APPEAL APPLICATION **CALIFORNIA ENVIRONMENTAL QUALITY ACT (CEQA)** **Instructions and Checklist**

Environmental Case Number: ENV-2020-428-CE

Project Address: 464 Crane Boulevard

This firm represents Crane Boulevard Safety Coalition ("Appellant" or "Coalition"). The Coalition is an organization dedicated to the protection of both the local community and the environment. On or about December 28, 2021, the City of Los Angeles ("City") issued a Letter of Determination ("LOD") denying an appeal brought by the Coalition and approving certain entitlements for the development project located at 464 Crane Boulevard ("Project"). The East Area Planning Commission also determined that the Project was exempt from the California Environmental Quality Act ("CEQA"). Coalition hereby appeals the categorical exemption for the Project pursuant to Public Resources Code Section 21151(c)¹. This letter outlines the justifications for the CEQA appeal.

Code Violation Information

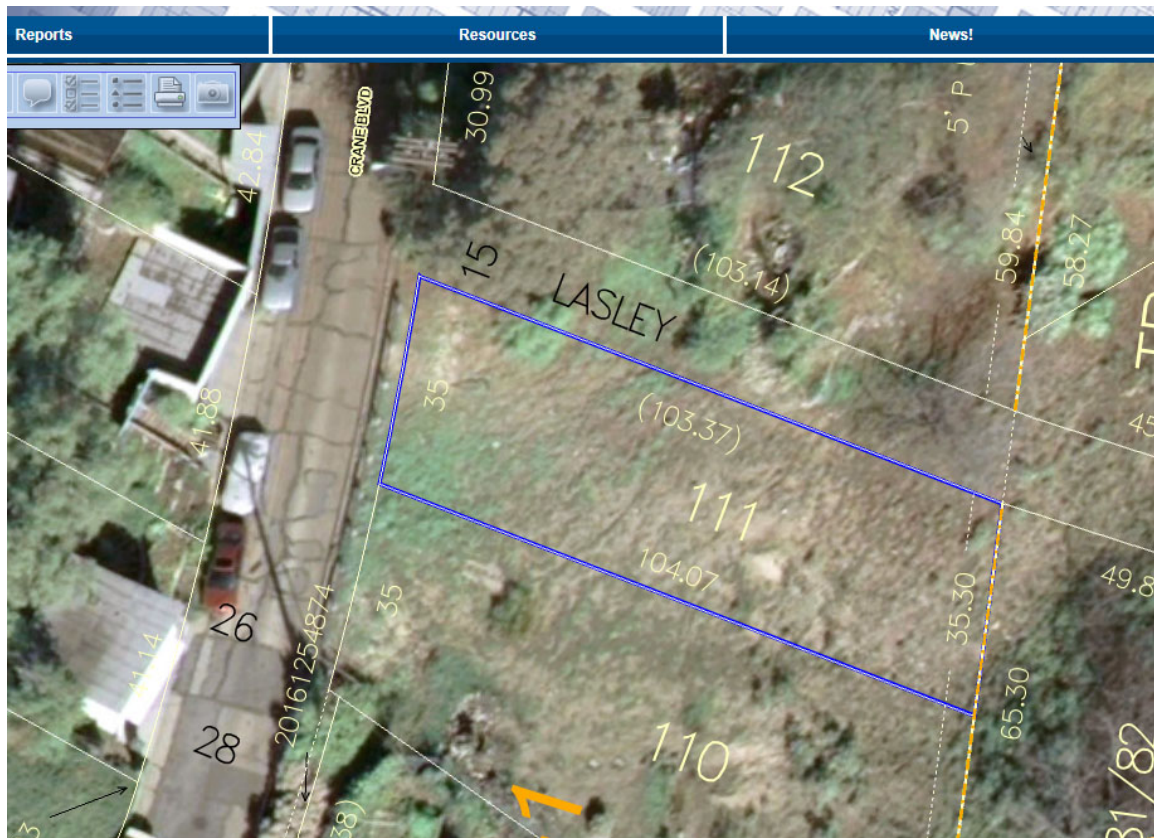
While neighbors witnessed replacement trees being planted (at the lower part of the lot), they also witnessed no watering or establishment of the replacement trees. The replacements were never properly established and died within the first year. The City enforcement action required, as the LADBS documentation above shows, that the owner was to arrange for further inspection before any further work was to commence. The current tree report before you fails to disclose this history and to account for the failure of the required replacement trees to become established.

As a result, you should require a new tree report that accounts for this past history and that recommends how the current owner intends to cure the violation and meet the requirements of the enforcement.

FIGURE 1 – SITE MAPS AND CHARACTERISTICS

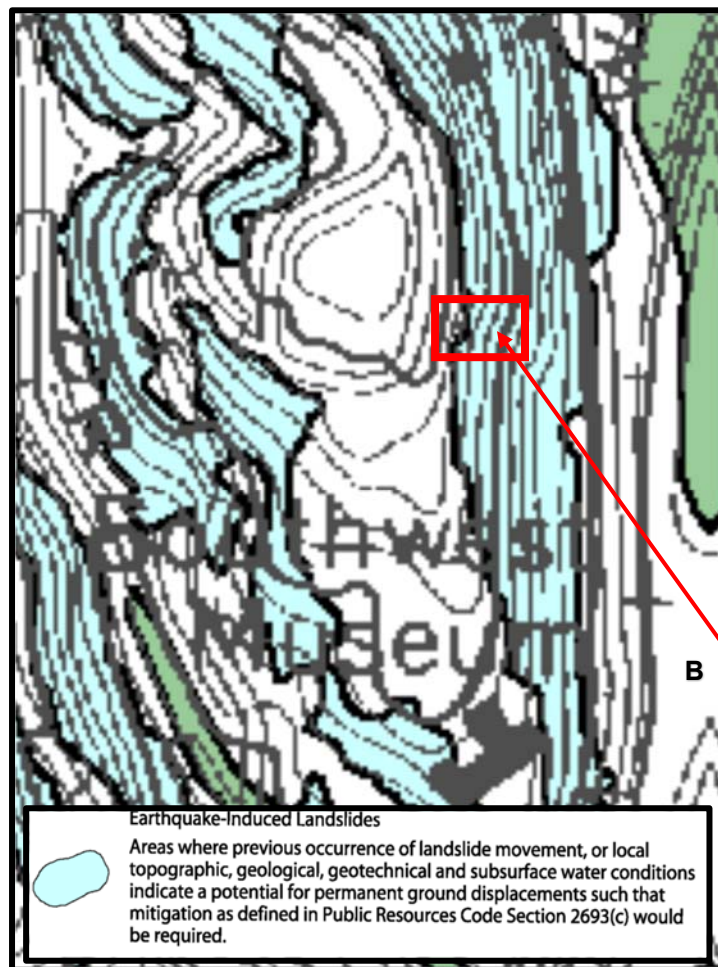
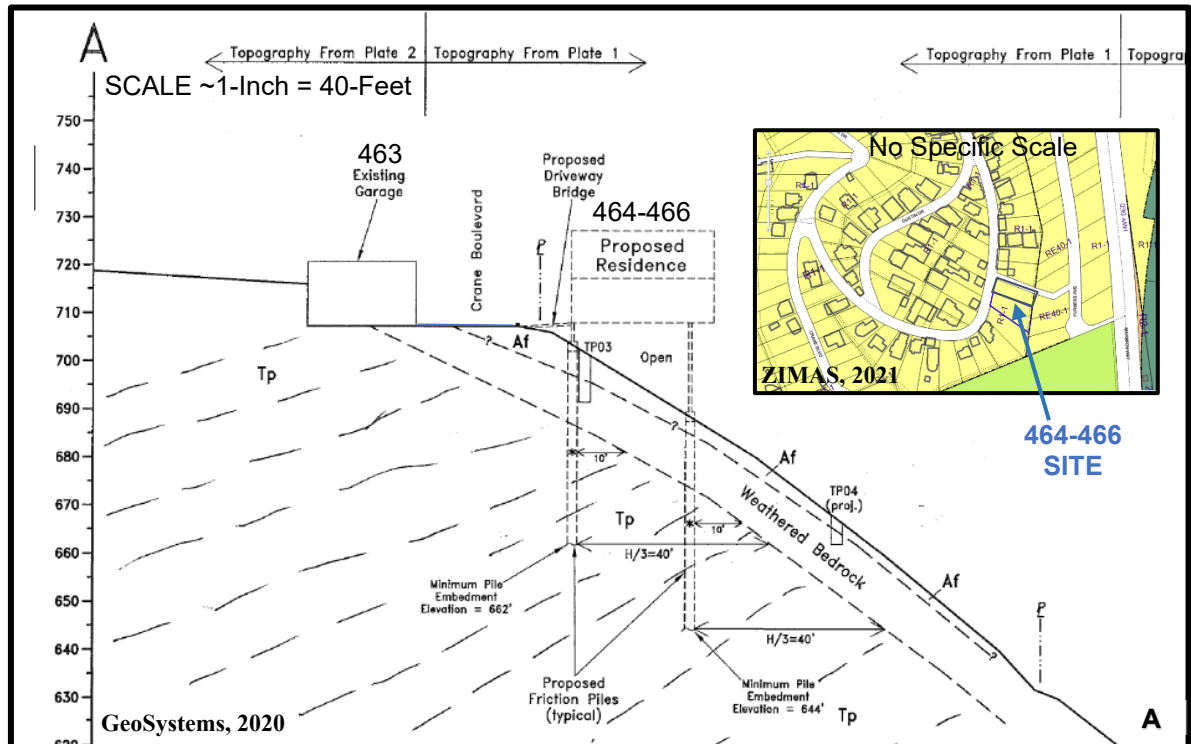
Measurements of bedrock bedding strike and dip indicate generally southwest dipping beds in the range of 20- to 30- degrees. *Cross-section A-A' (Figure 1A) appears to use the actual dip angle and does not compensate for the strike, which is not at all perpendicular to the cross-section. With strikes of north 14 west (N14W) to N85W, the apparent dips on the cross-section should be much flatter. This GeoSystems depiction is much more favorable than the actual condition suggests. When combined with joints and fractures in the bedrock, these very low apparent bedding angles that should be depicted on A-A' could result in lower factors of safety than presented by GeoSystems.* In the 2020 GeoSystems report, bedrock is described as slightly to moderately fractured with joints and fractures described as steeply dipping, randomly oriented, and

GeoSystems report (page 6) describes the bedrock as Tps, yet their geology map (page 31) uses Tpss and Tpsh for the sandstone and shale members (also see **Figure 1C**; Bedrossian and Roffers, 2012). *They do not mention these member differences nor do they show any of these differences on their cross-section A-A’ (page 32).* The GeoSystems geology map (their Plate 3) also shows upfolds and downfolds (anticlines and synclines) in the areas around the site. *The presence of these local changes in bedding attitudes are not mentioned or discussed and could have an impact on slope stability. Also, without mapping the slope below the site to determine if such local changes may exist they are assuming the regional map is representative. In addition, the GeoSystems boring location is not shown on the cross-section to determine correlation with the bedding shown and any impact on the slope stability calculations.*
